November 17, 2025
Subject: Pleasant Avenue Crossing
Bridge Wearing Surface
Replacement
State WIN: 023120.00
Location: **Dover Foxcroft**
Amendment No. 4

Please make the following changes to the Bid Documents:

DOVER BRIDGE
PISCATAQUIS RIVER
DOVER-FOXCROFT PISCATAQUIS COUNTY
SUPERSTRUCTURE DETAILS
(1 OF 2)

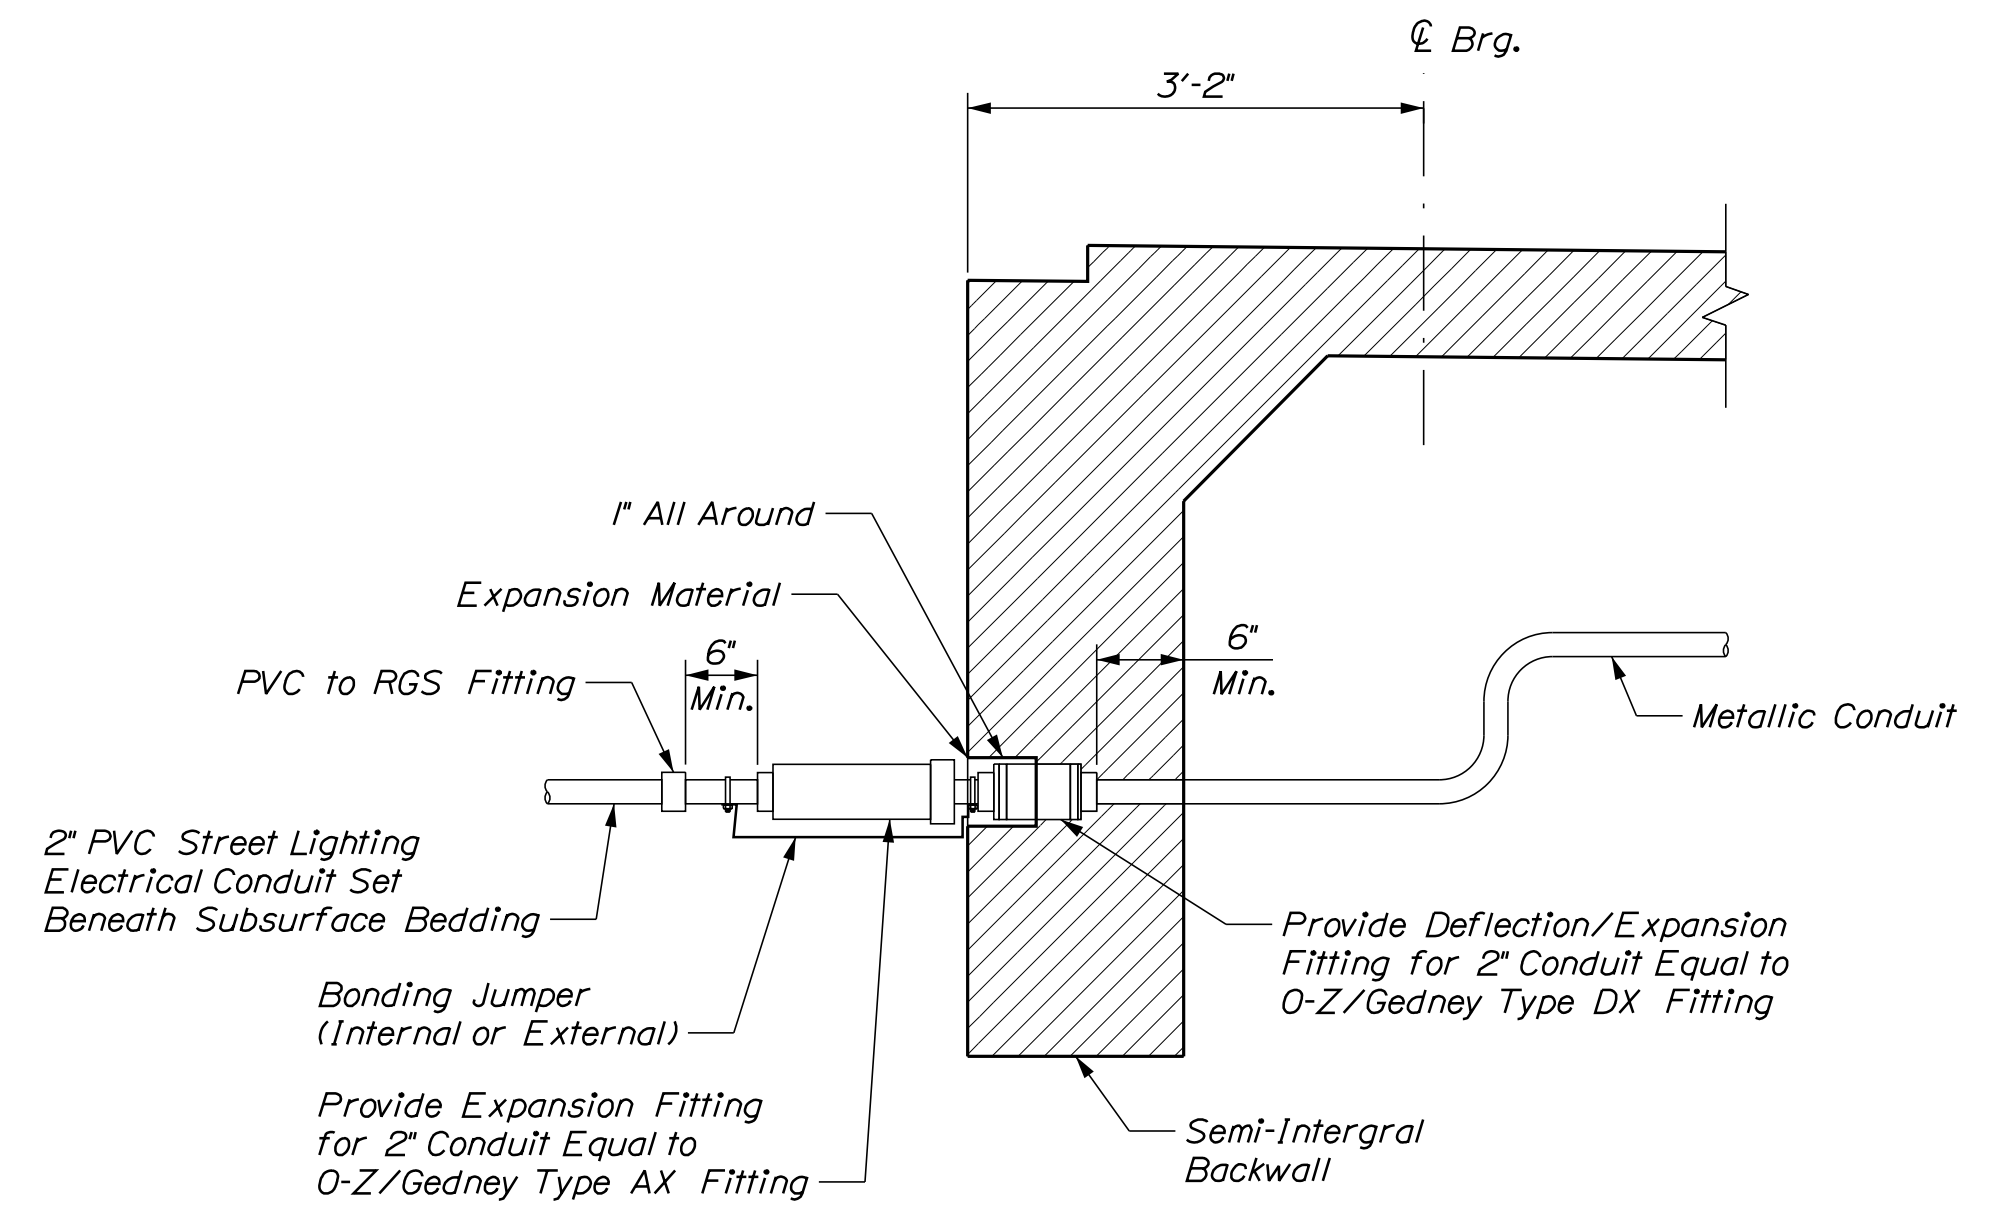
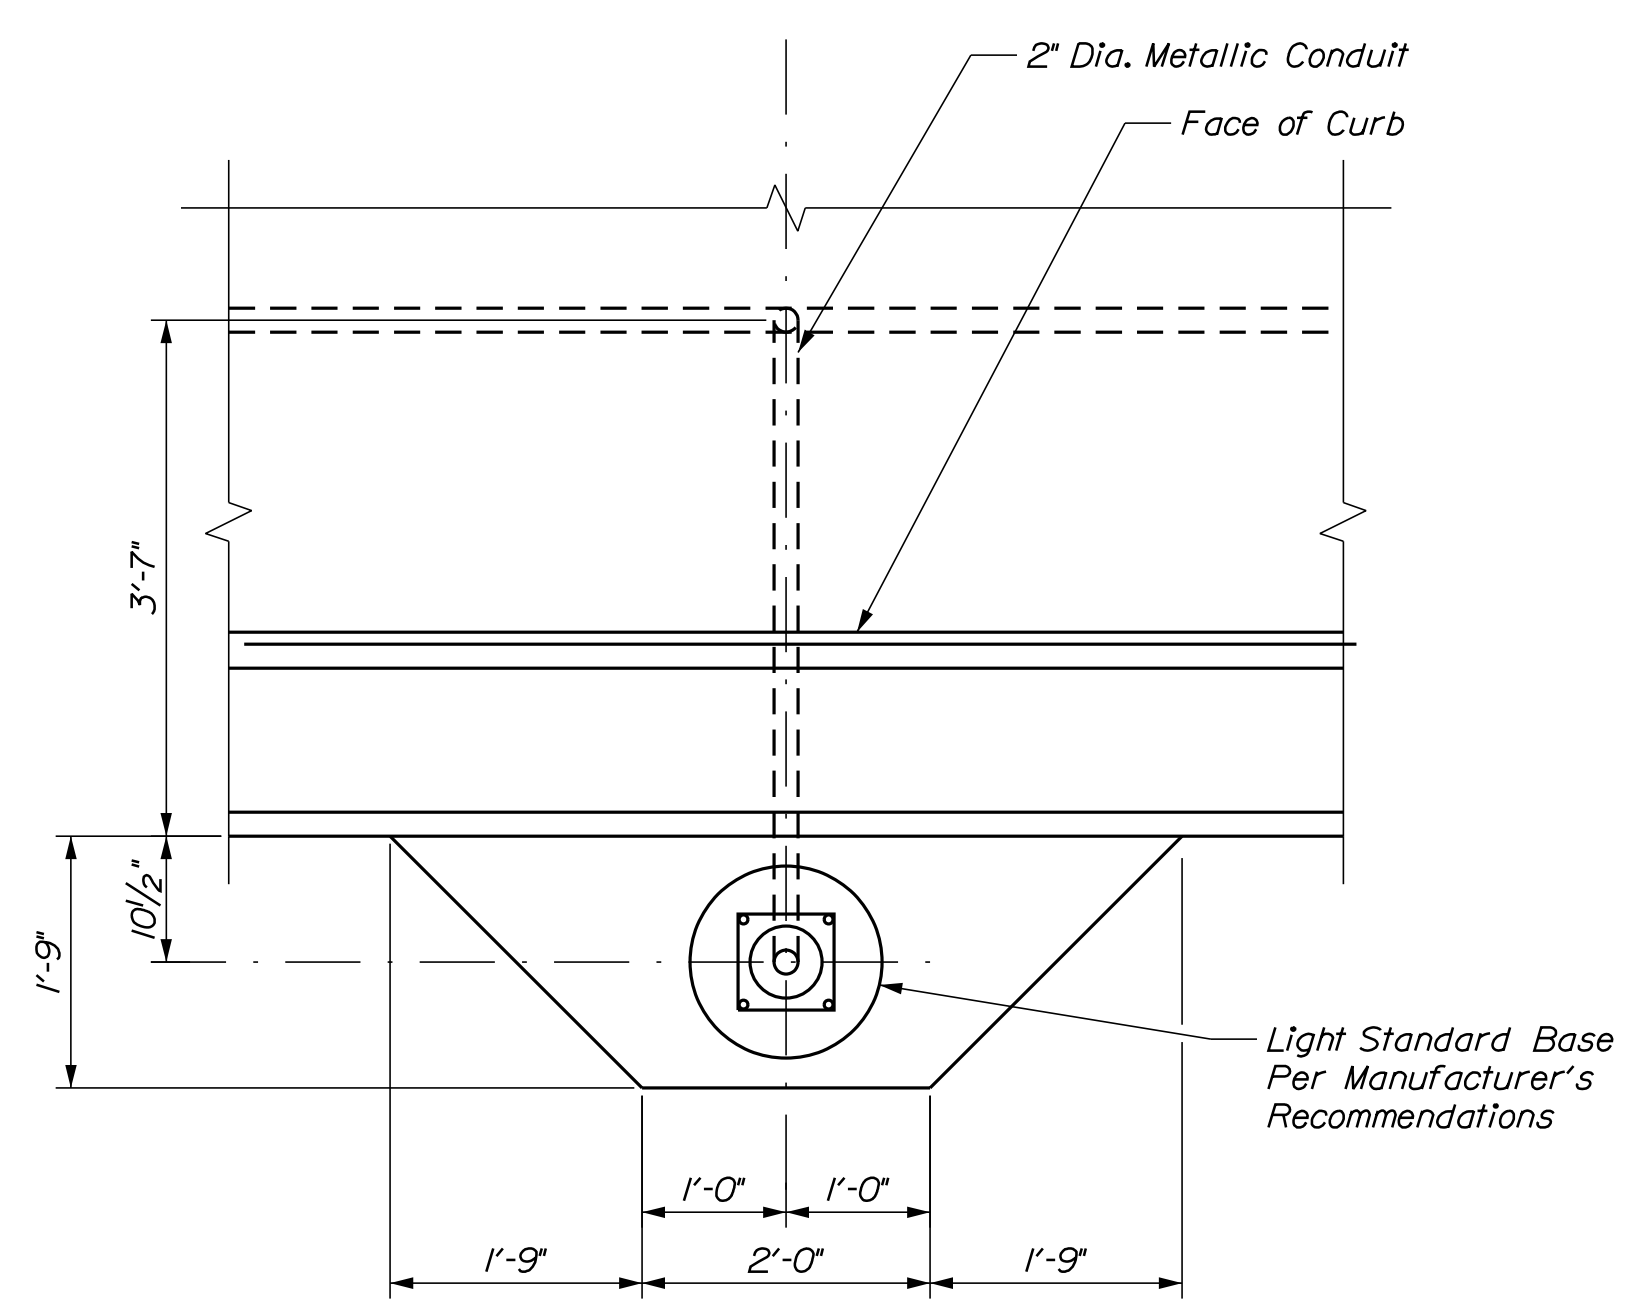
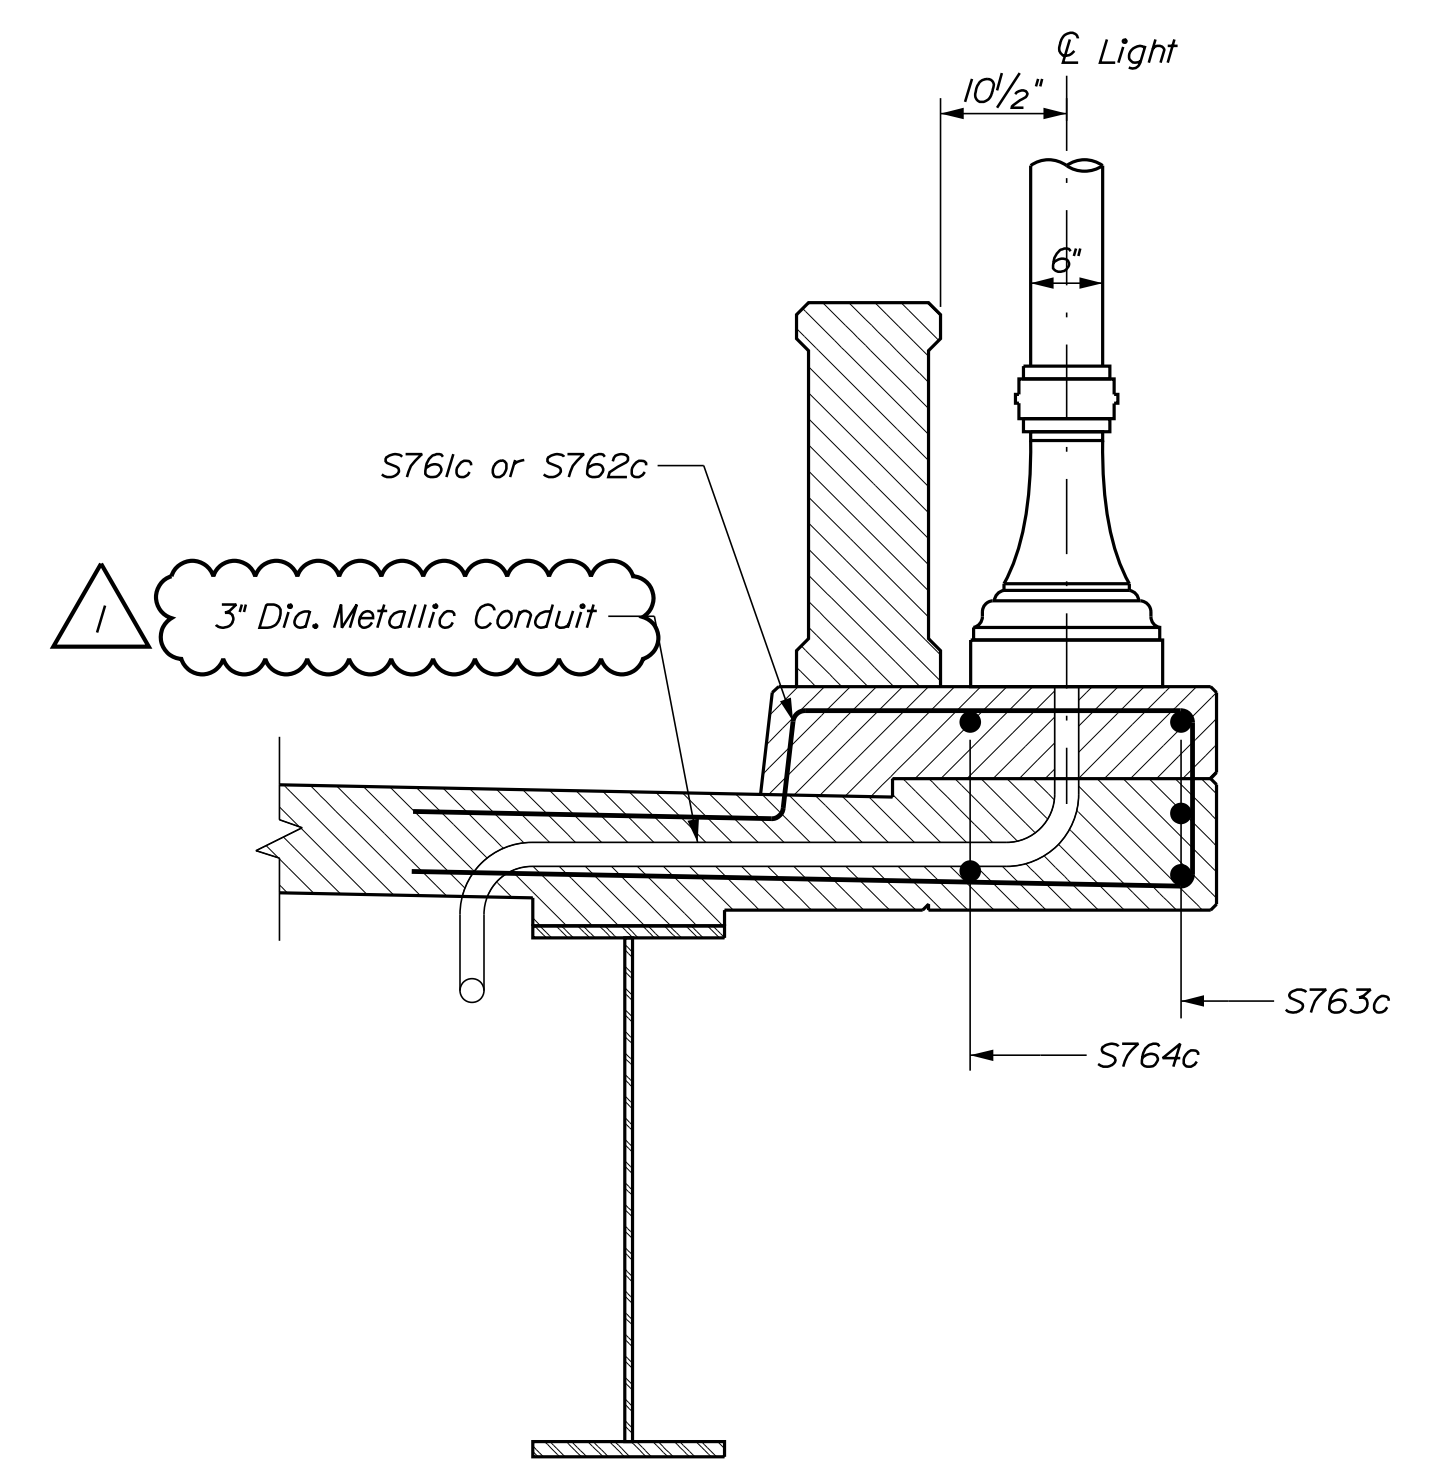
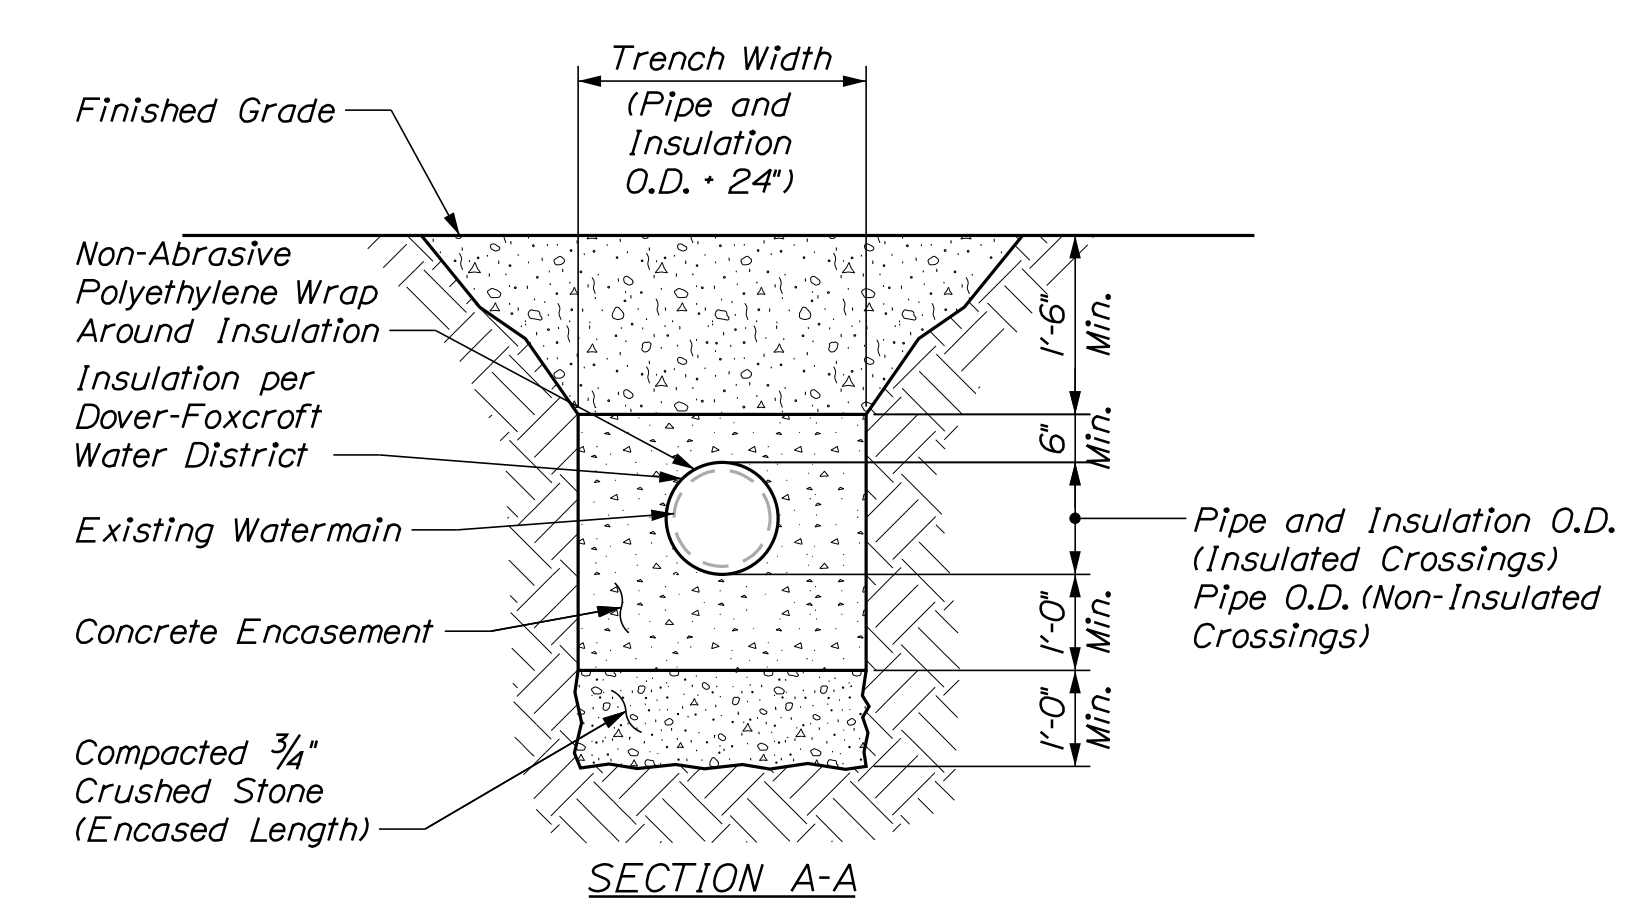
Question: The details on page 55 in the plans states that the lighting conduit will be 2 inch, the conduit schedule on page 59 states that lighting conduit is 3 inch, which one is correct? Will the conduit be supported under the bridge or will the conduit be installed in the bridge deck?

Question: The conduit and conductor schedule on Sheet 59 specifies 3" conduit, the details on Sheet 55 shows 2" conduit. Which should be used?

Response: The lighting conduit size noted on sheets 47 and 55 has been changed from 2” diameter to 3” diameter. Please reference the revised sheets 47 and 55. The conduit will be supported under the bridge by Utility Support Type T2 as indicated on sheet 47. Type T2 support shall be installed between G4 and G5 as shown on the framing plan on sheet 45.

Response: The conduit shall be 3" diameter.
